## Comments from Öko-Institut on the ENTSOs TYNDP 2020 Draft Scenarios

Freiburg, 15.01.20

## **Planning the European electricity and gas infrastructure needs a greater scenario diversity, including a 100% RES scenario and efficient direct electrification resulting in faster GHG reductions using less unproven technologies (such as CCS).**

**Figure 1-1: GHG emissions compared to 1990 level**

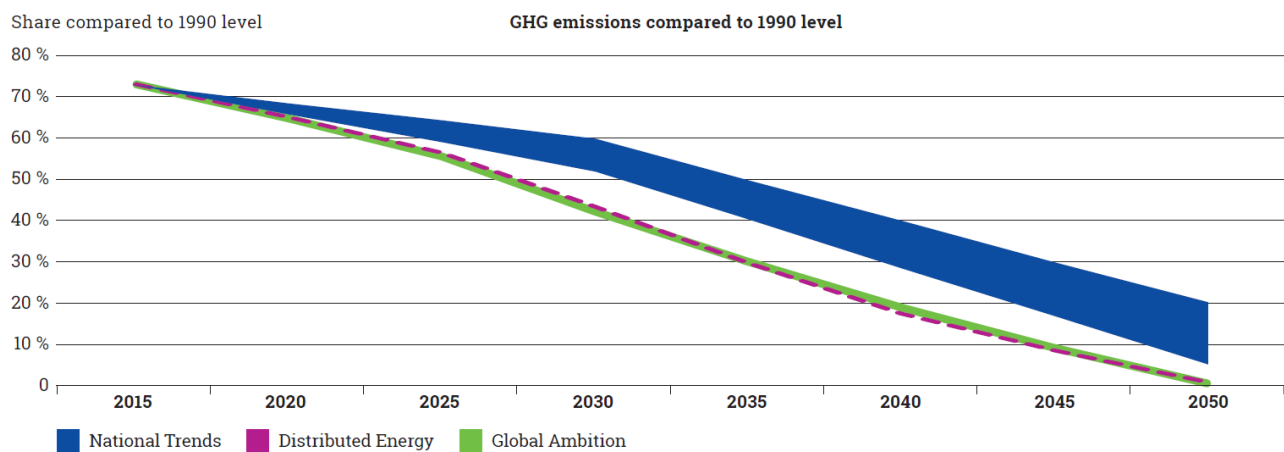
The two ambitious scenarios show, with a linear reduction between 2025 and 2050, the same development in emission reductions (see Figure 1-1). A comparison of emissions in the electricity sector shows that in 2030 even all three scenarios are at the same level. In order to maintain an ambitious GHG budget, it is essential to reduce emissions at an early stage. As these early efforts can also unfold their effect in all subsequent years. Since this is not implemented in the TYNDP scenarios, the set overall budget is exceeded before 2035. All subsequent emissions must be later removed from the atmosphere. For this reason, after achieving climate neutrality in 2050, approximately 15 Gt will have to be offset by negative emissions until the year 2100. The decision for a linear emission reduction and the resulting need to withdraw emissions from the atmosphere is seen critically for the following reasons:

- Carbon Capture and Storage or Usage (CCS/CCU) technologies are not yet tested on a large scale. There are also unanswered questions regarding their implementation costs or the acceptance of final disposal.
- These uncertainties lead to a shift of responsibility and costs from the generation that draws up these plans to following generations.
- It doesn't reveal itself why the emission reduction was defined as a linear path. This approach puts the Paris-compatibility of the scenarios at risk, as it is unclear whether the required carbon capture technologies will be available.
- At least one scenario should consider a faster emission reduction to reduce the dependency on CCS.

**Figure 2-1: Installed wind and solar capacities for EU28**

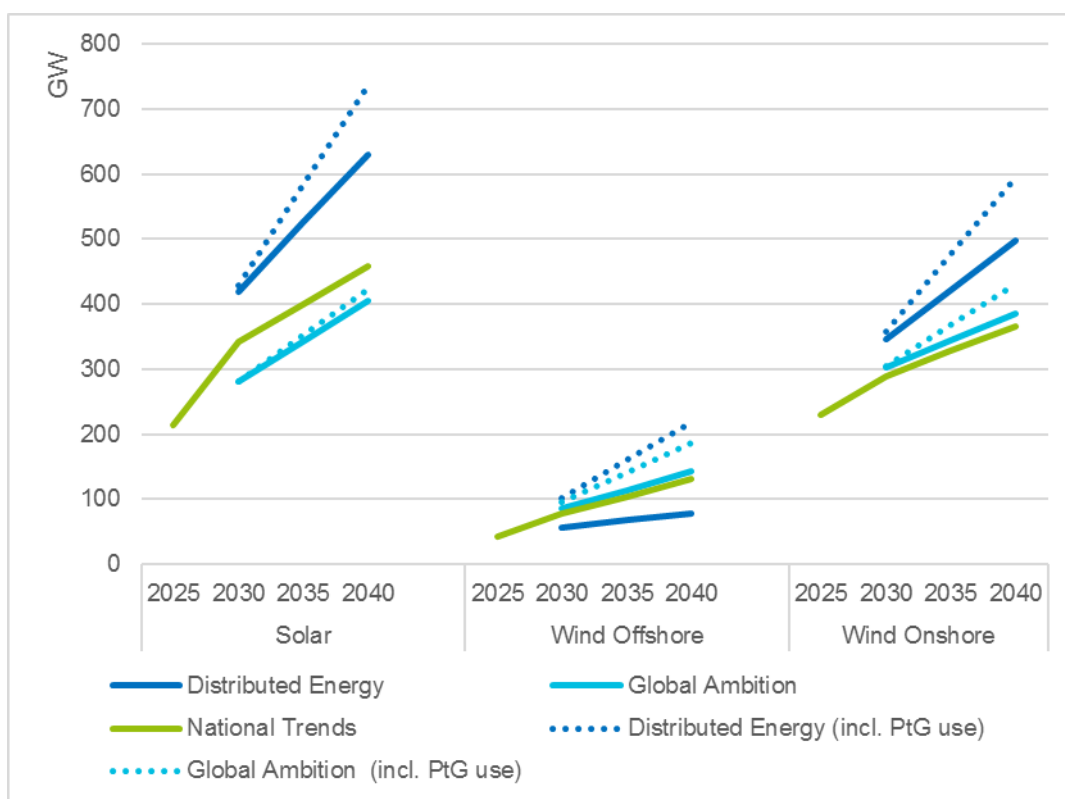
In Figure 2-1 the installed wind and solar capacities for EU28 are shown. It should be noted that in the Paris scenarios, wind and solar systems are foreseen, whose electricity is used exclusively for Power-to-Gas (PtG) applications (dotted lines). This is approach is discussed in chapter 4.

The installed grid-connected solar capacities are much lower than in the TYNDP 2018 (-110 GW Distributed Generation and -180 GW Global Climate Ambition). If the plants used for PtG production are also included the Distributed Scenarios reach roughly the same level. It would have been expected that the additional efforts to achieve a 1.5° scenario would result in additional solar capacity and not in an equal level or even capacity reduction.

**Figure 2-2: Projected Electricity Demand and Wind/Solar Generation for EU28**

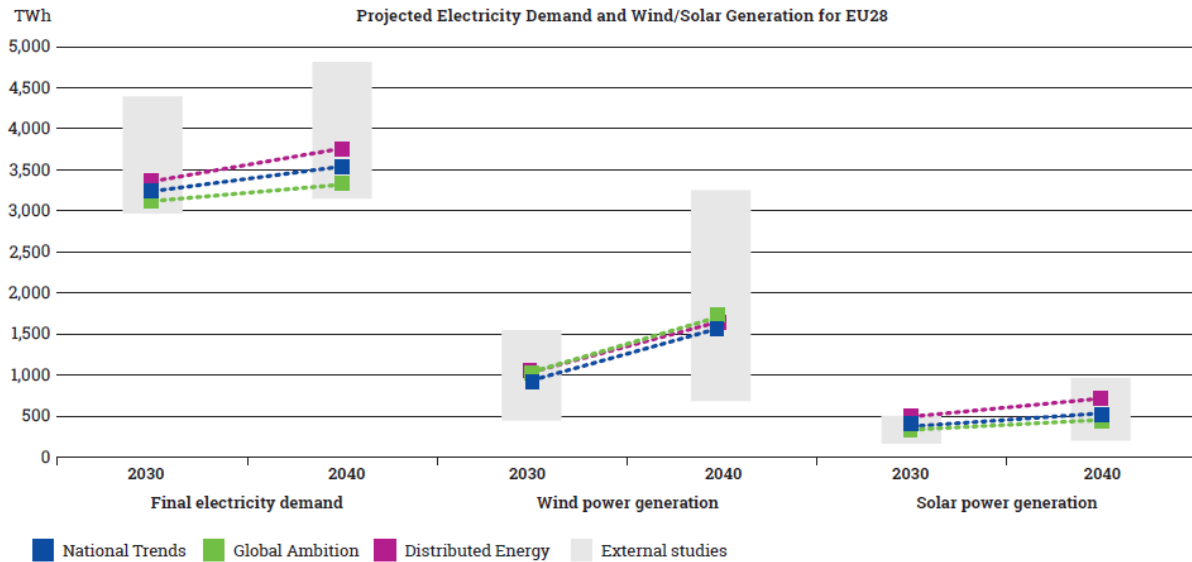
Compared to the last TYNDP, the wind capacities increase significantly, but in comparison to other scenarios the wind generation for the year 2040 is in the lower third (see Figure 2-2). The grid-connected wind capacities of the Global Ambition scenario are roughly at the level of national trends; a significant increase in capacity would have been expected for a 1.5° scenario. In line with the storyline, the grid-connected offshore capacities of the Distributed Energy Scenario are signifi-

cantly lower. But if the plants for PtG use are considered, the offshore capacities are almost three times higher and even exceed the capacities of the Global Ambition scenario.

- the electricity demand is relatively low compared to other studies (it is only in the lower half of the scenario range as can be seen in Figure 2-2 as well as for the amount of heat pumps as an indicator for the electrification of heat supply which is shown in figure of 11 of (ENTSO-E; ENTSOG 2019, p. 22)) and
- the gas demand is above the 1,5°C scenarios from the EC long term strategies and other ambitious scenarios (ENTSO-E; ENTSOG 2019, p. 42) and
- renewable gases and CCS are the main decarbonisation strategies.

**Figure 4-1: Installed Power-to-Gas and dedicated RES-E plants**

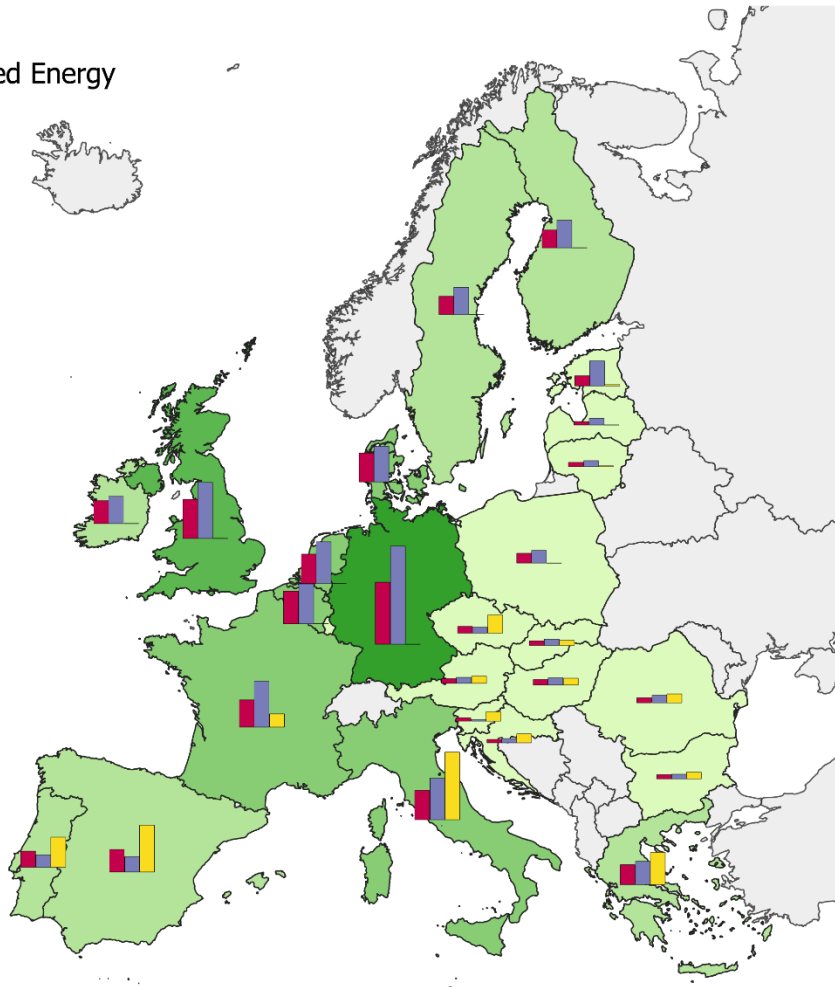
We question, why overall capacities for RES-E dedicated to PtG production exceed the capacity for P2G (see Figure 4-1). This assumption increases full load hours for P2G but also increases curtailment of RES-E generation. We question if this model can be economically feasible?
